**TOWNSHIP OF NORTH DUMFRIES
BUILDING DEPARTMENT**

These Plans have been examined for Compliance with the Ontario Building Code requirements. A Building Permit has been Issued, subject to any changes noted, under the condition that the building will be constructed in accordance with the code.

Legacy

model
36-01

BASEMENT PLAN ELEV. 'B', 'C', 'D'

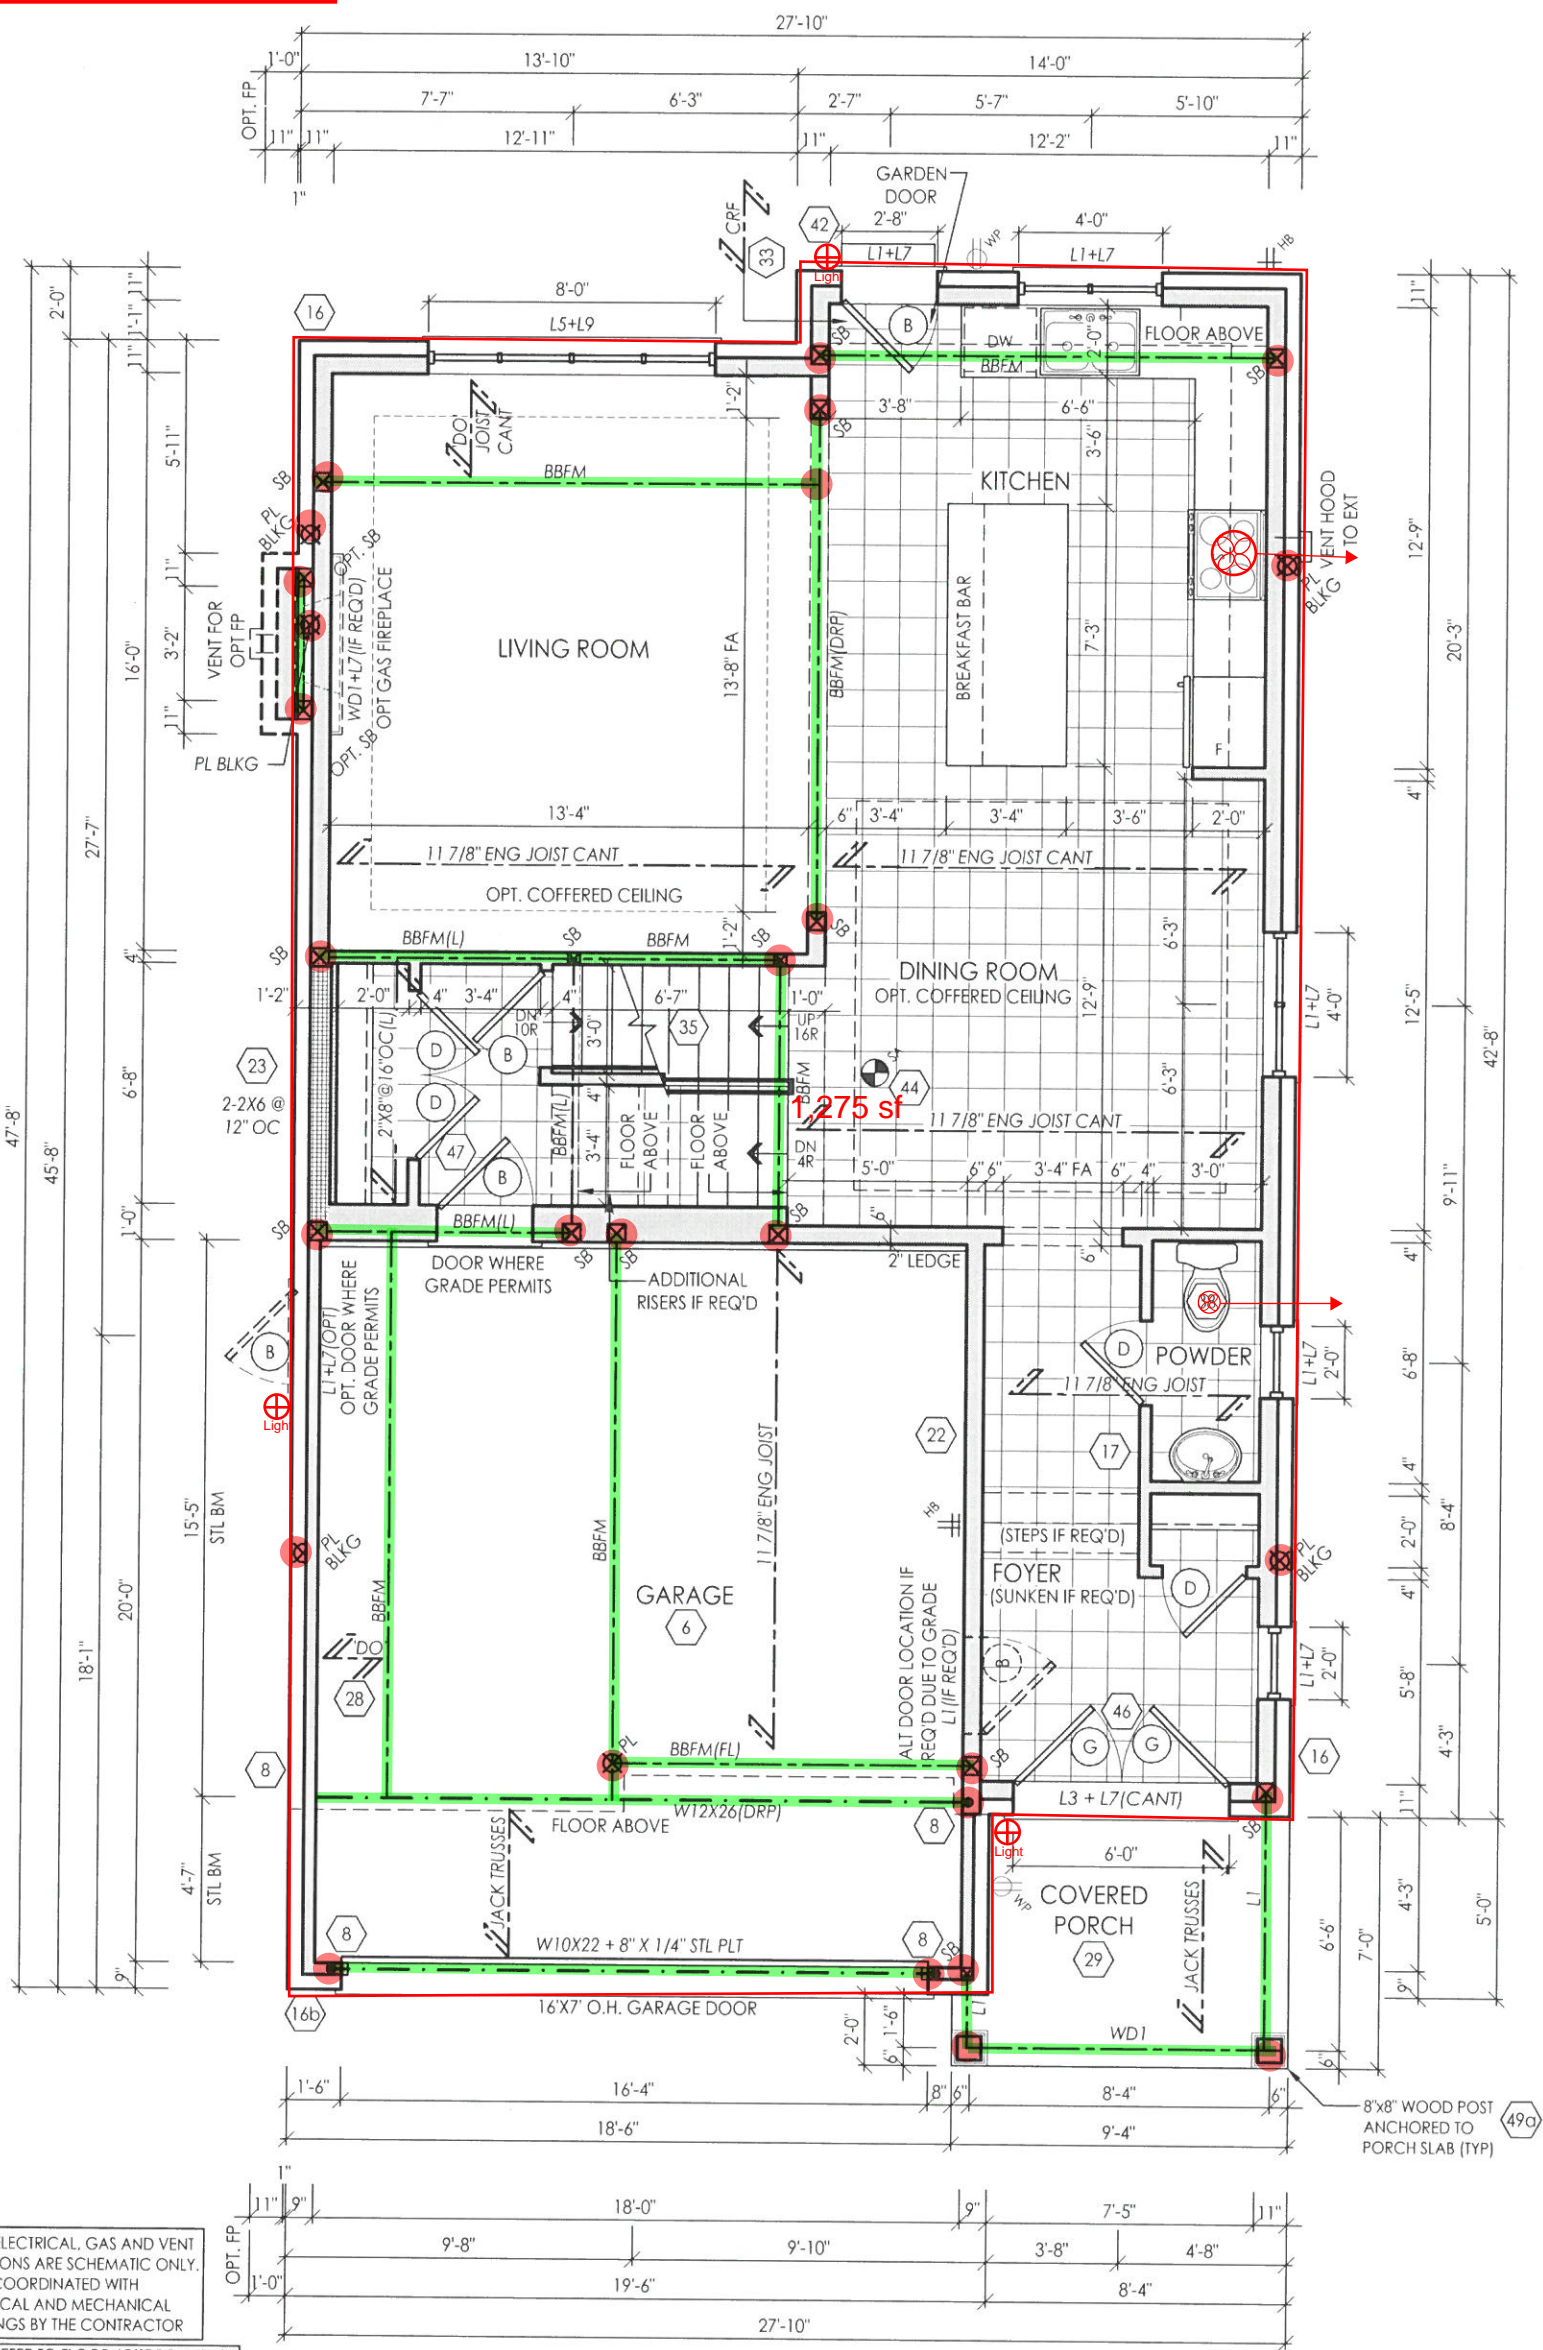
A SEPARATE BUILDING PERMIT WILL BE REQUIRED TO FINISH THE BASEMENT.

THE COLD CELLAR DOOR NEEDS TO BE INSULATED AND WEATHER-STRIPPED.

SECOND FLOOR ELEV. 'D'

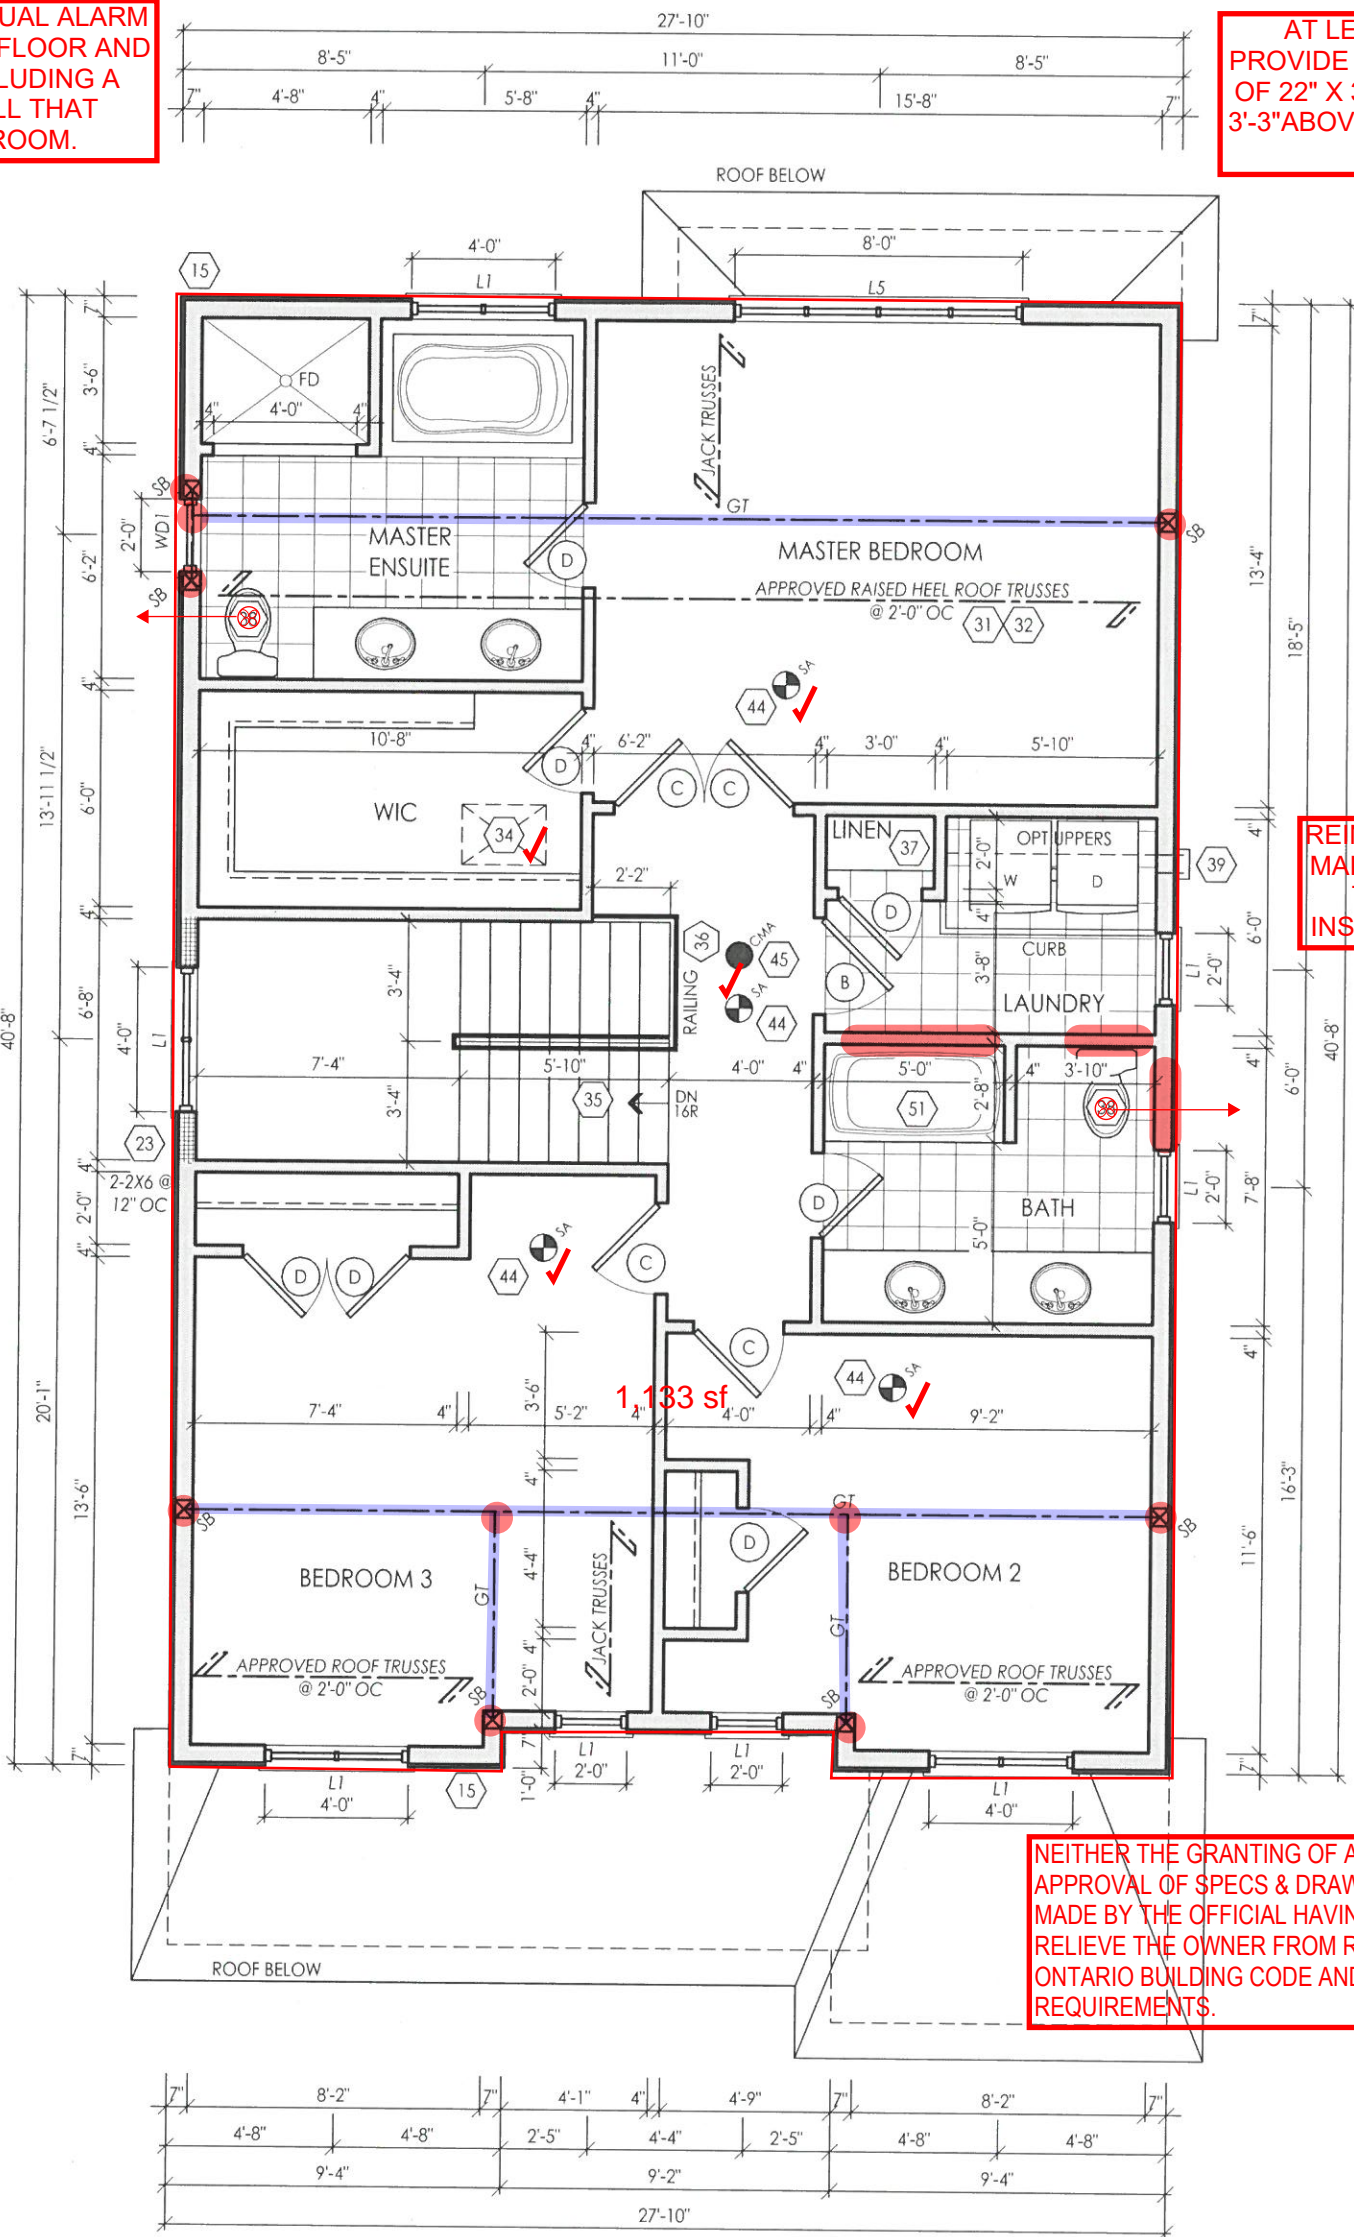
SMOKE ALARMS WITH VISUAL ALARM ARE REQUIRED ON EACH FLOOR AND IN EACH BEDROOM INCLUDING A SMOKE/CO IN THE HALL THAT SERVICES THE BEDROOM.

AT LEAST 1 WINDOW SHALL PROVIDE AN UNOBSTRUCTED AREA OF 22" X 39" W/ A SILL HEIGHT MAX. 3'-3" ABOVE FINISHED FLOOR & 23'-0" ABOVE GRADE

TALL WALL REQUIREMENTS
 (A) THE STUDS ARE CLAD WITH NOT LESS THAN 9.5 MM THICK PLYWOOD, OSB OR WAFERBOARD SHEATHING ON THE EXTERIOR FACE, AND NOT LESS THAN 12.5 MM GYPSUM BOARD ON THE INTERIOR FACE,
 (B) SOLID BRIDGING IS PROVIDED AT NOT MORE THAN 1.2 M.O.C.,
 (C) THE STUDS ARE FASTENED TO THE TOP AND BOTTOM PLATES WITH NO FEWER THAN THREE 82 MM TOE-NAILS,
 (D) THE DOUBLE TOP PLATES ARE FASTENED TOGETHER WITH NOT LESS THAN 76 MM NAILS SPACED NOT MORE THAN 200 MM O.C.,
 (E) ROOF FRAMING MEMBERS SPACED NOT MORE THAN 610 MM ARE FASTENED TO THE TOP PLATES WITH NO FEWER THAN FOUR 82 MM TOE-NAILS, AND
 (F) THE BOTTOM PLATE IS FASTENED TO THE FLOOR JOISTS, BLOCKING OR RIM JOIST WITH NOT LESS THAN 82 MM NAILS SPACED NOT MORE THAN 200 MM O.C.

REINFORCEMENT REQUIRED IN MAIN BATHROOM STUD WALLS TO PERMIT THE FUTURE INSTALLATION OF GRAB BARS.

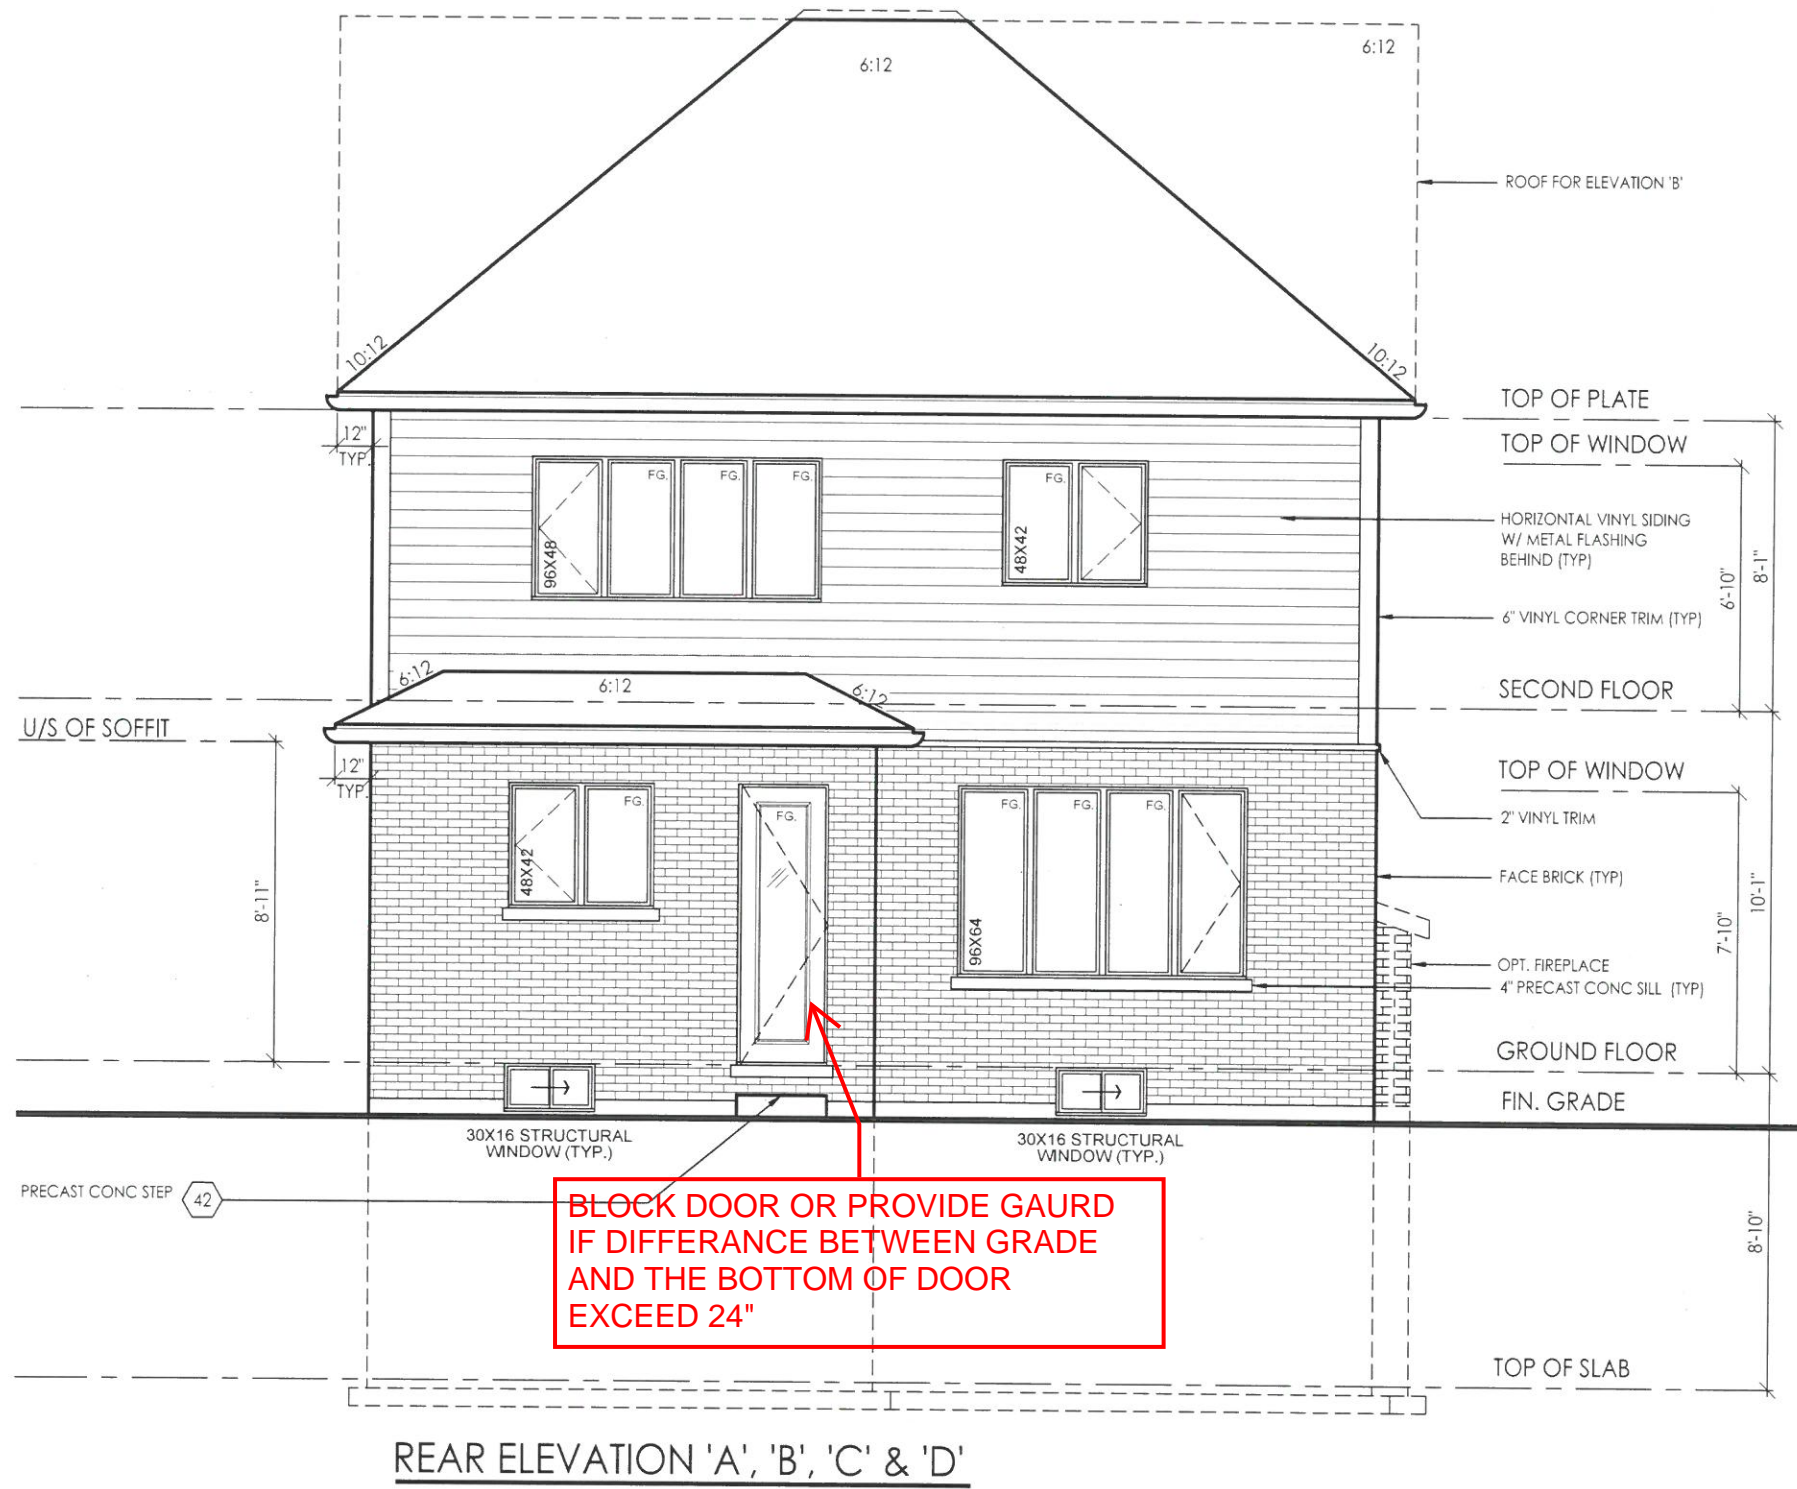
BLOCK DOOR OR PROVIDE GAURD IF DIFFERANCE BETWEEN GRADE AND THE BOTTOM OF DOOR EXCEED 24"
